ADDENDUM 1  
TO THE  
COWAL GOLD PROJECT  
EROSION AND SEDIMENT CONTROL MANAGEMENT PLAN

SEPTEMBER 2004  
Project No. HAL-02-07/1/7  
Document No. AD-ESCMP-A

**FIGURE A**  
Water Management Layout

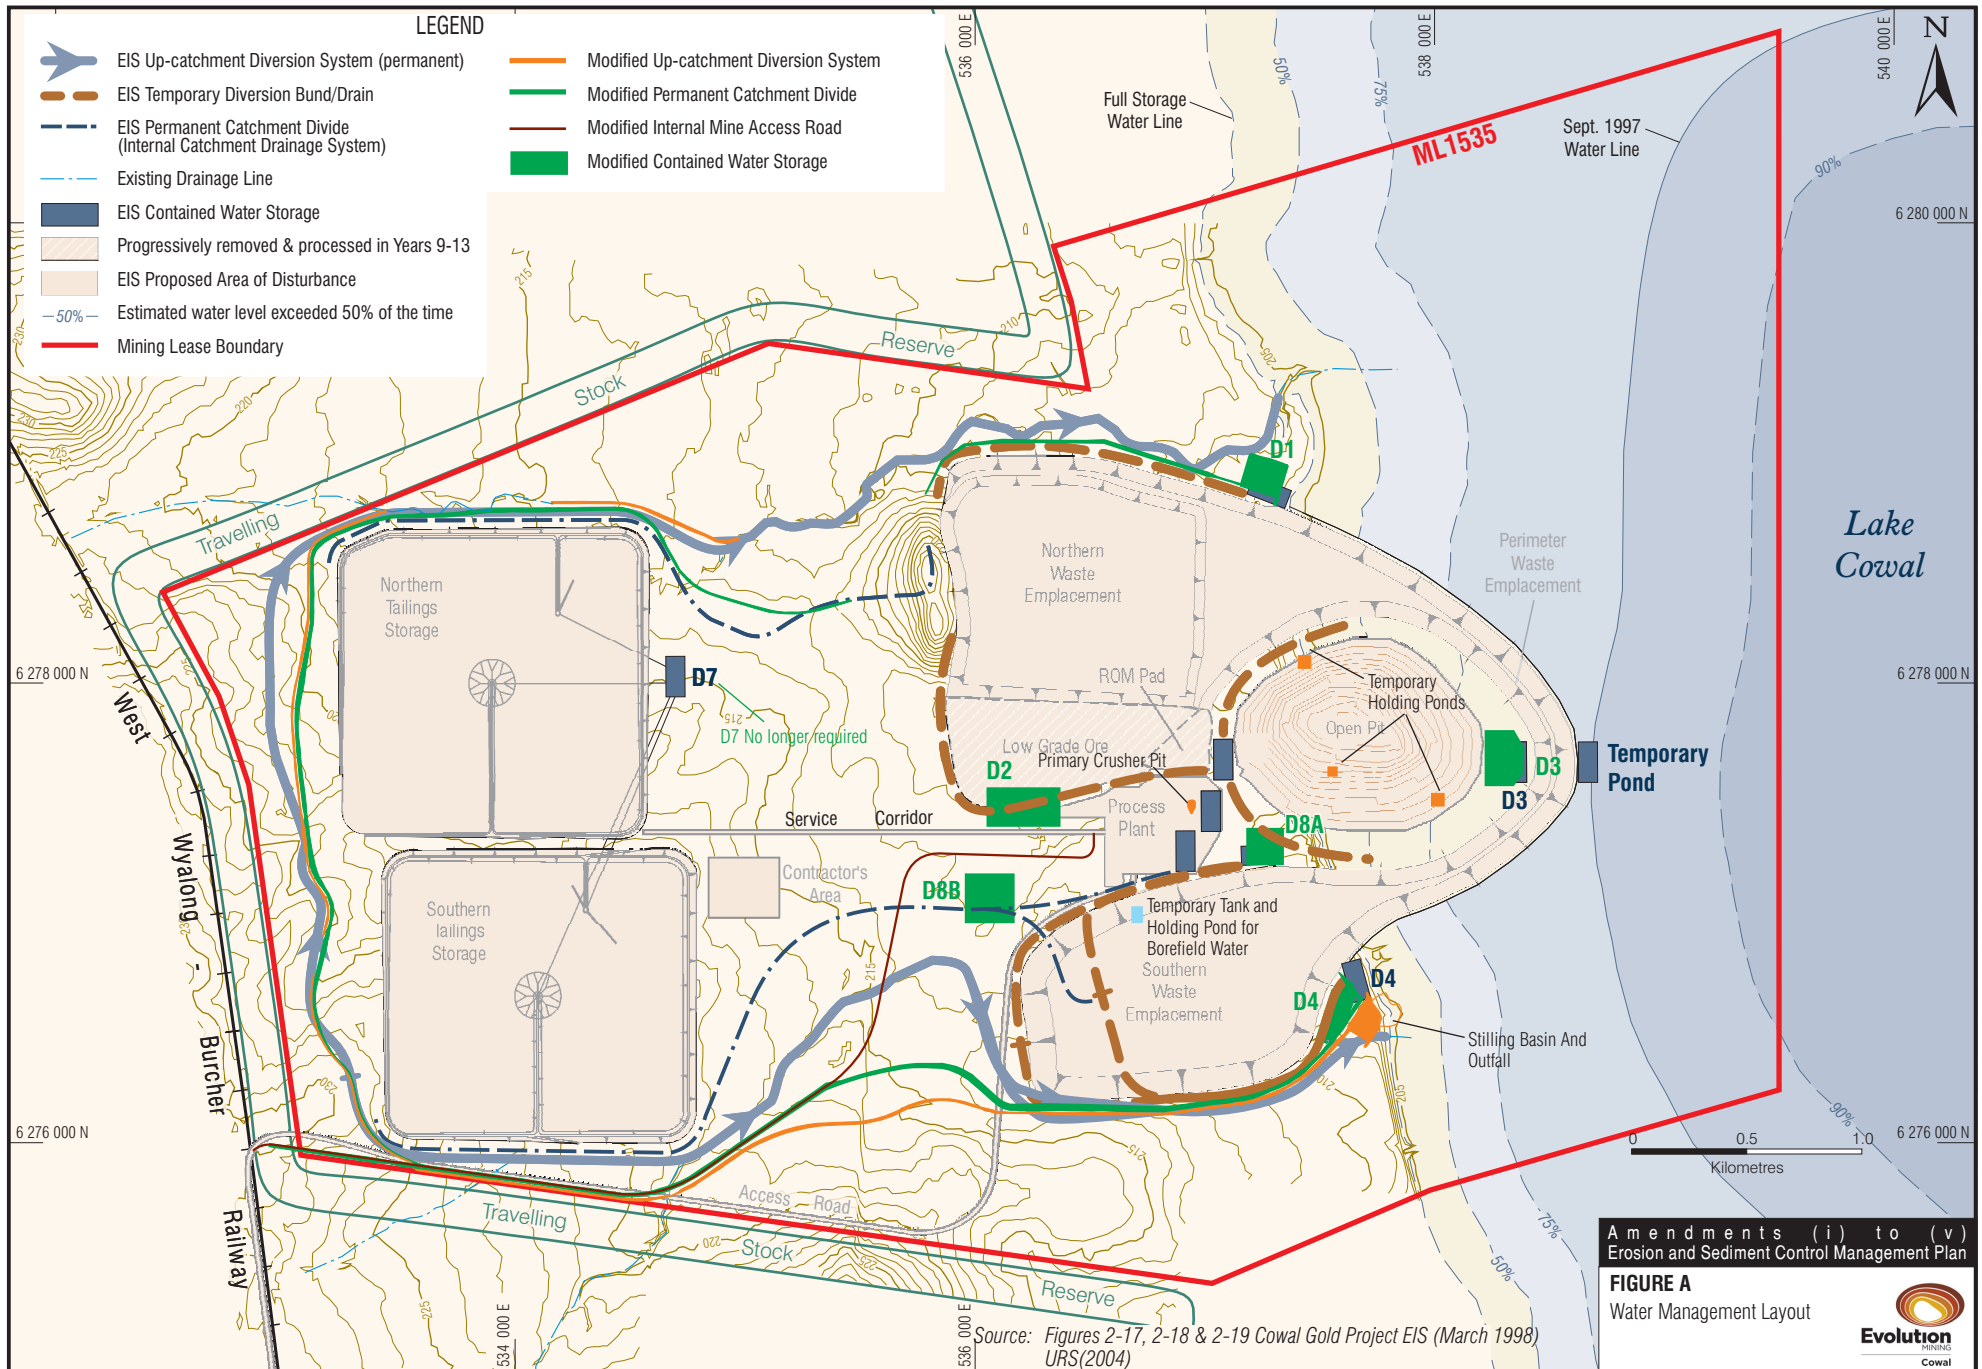
Barrick propose that during the development of the pit dewatering bores (including the cleaning of drilling fluids and fine material) saline water will be transferred via pipelines from mud pits adjacent the drill rig to three (3) Temporary Holding Ponds excavated within the open pit outline and behind the lake isolation bunds. The approximate locations for the Temporary Holding Ponds are shown on Figure A (attached). Figure A also shows the modifications to the up-catchment diversion system, permanent catchment divide, internal mine access road and contained water storages as made in the application to the Minister for Planning under s 96(1A) of the *Environmental Planning and Assessment Act 1979* in June 2004.

It is anticipated that the development of the pit dewatering bores will result in discharge of between 20 and 500 kilolitres (kL) per day for up to several days per bore. The Temporary Holding Ponds will be constructed to safely contain between 5,000 kL and 10,000 kL. Detailed plans and/or diagrams (endorsed by a suitably qualified engineer) for the Temporary Holding Ponds would be submitted by Barrick to the EPA for approval.

It is proposed that until the Process Water Storage (D6) is constructed, water from the borefield will be transferred via the pipeline to a temporary pipeline terminus located within the footprint of the Southern Waste Emplacement. Water will be temporarily stored in a tank and supplemented for any overflow by an earthen Temporary Holding Pond excavated within the Southern Waste Emplacement footprint. The proposed location for the Temporary Tank and Holding Pond are shown on Figure A (attached). Figure A also shows the modifications to the up-catchment diversion system, permanent catchment divide, internal mine access road and contained water storages as made in the application to the Minister for Planning under s 96(1A) of the *Environmental Planning and Assessment Act 1979* in June 2004.
